# Service Bulletin

Nr. / no. **013-2018**

### Störung bei der Münzannahme des Münzprüfers Version V7

### Malfunction at the coin acceptance of the coin validator version V7

Münzprüfer Version 7  
Coin acceptor version 7

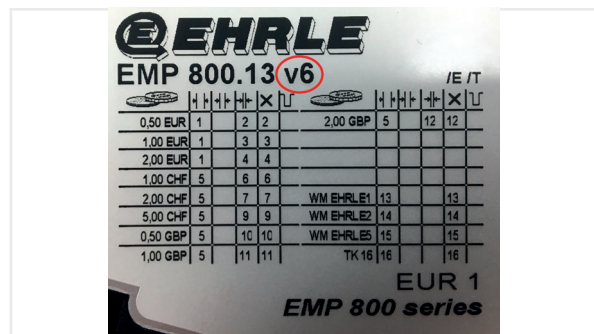
In einzelnen Fällen kann es beim Münzprüfer Version V7, der ein anderes Messsystem hat, zu einer Störung kommen, durch die einzelne Münzen nicht korrekt angenommen werden. Durch Austausch der Version V7 durch die Version V6 kann das Problem behoben werden. Beantragen Sie hierzu über unsere Internetseite eine RMA Nummer. Nach der Prüfung und Sachstandsermittlung erhalten Sie im Garantiefall einen Rücksendeaufkleber und -schein.

In individual cases, the coin acceptor version V7, which has a different measuring system, may experience a malfunction which may result in individual coins not being accepted correctly. The problem can be solved by replacing version V7 with version V6. You can apply for an RMA number on our website for this purpose. After the inspection and determination of the status you will receive a return sticker and return note in case of a warranty claim.
